**SERVICE INFORMATION BULLETIN**

**APPLICABILITY:** 2015-2018MY WRX and WRX STI  
**SUBJECT:** Timing Hole Plug- Design Change

**NUMBER:** 02-178-18  
**DATE:** 08/29/18

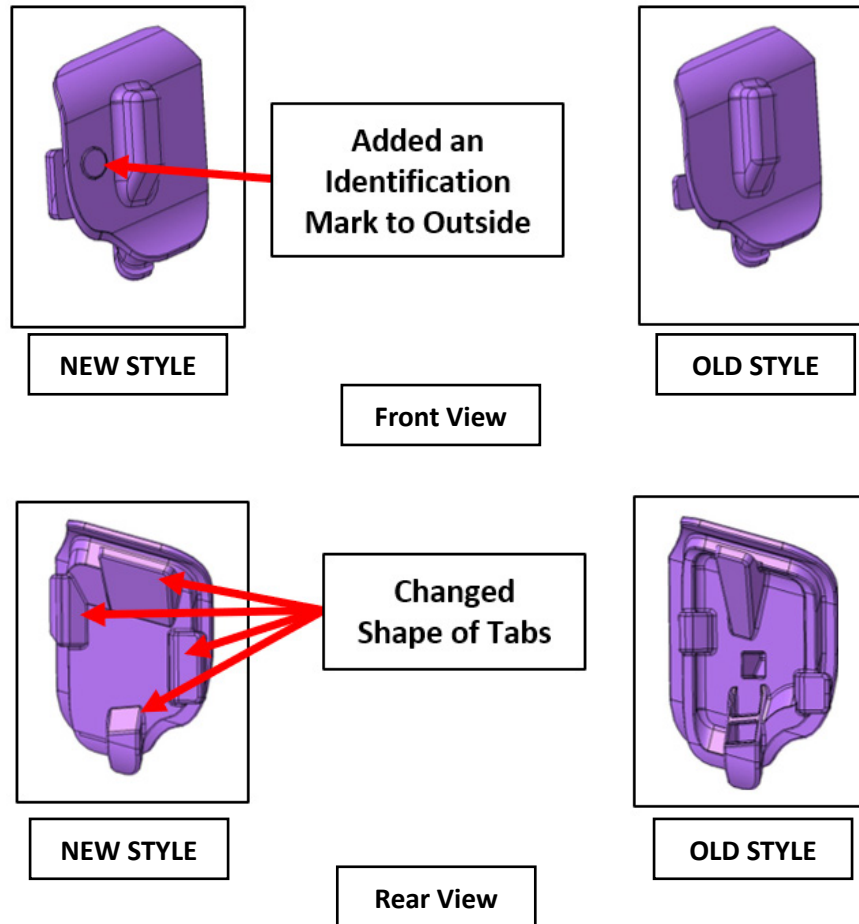
This Service Information bulletin announces a design change made to the rubber timing hole access plug to improve its retention and prevent water intrusion into the converter case.

The part number for the new timing plug is **11413AA120**. Comparison images for both the new and old-style plugs are provided below.

The new timing hole plug was incorporated into production starting with VIN **J9833467**.
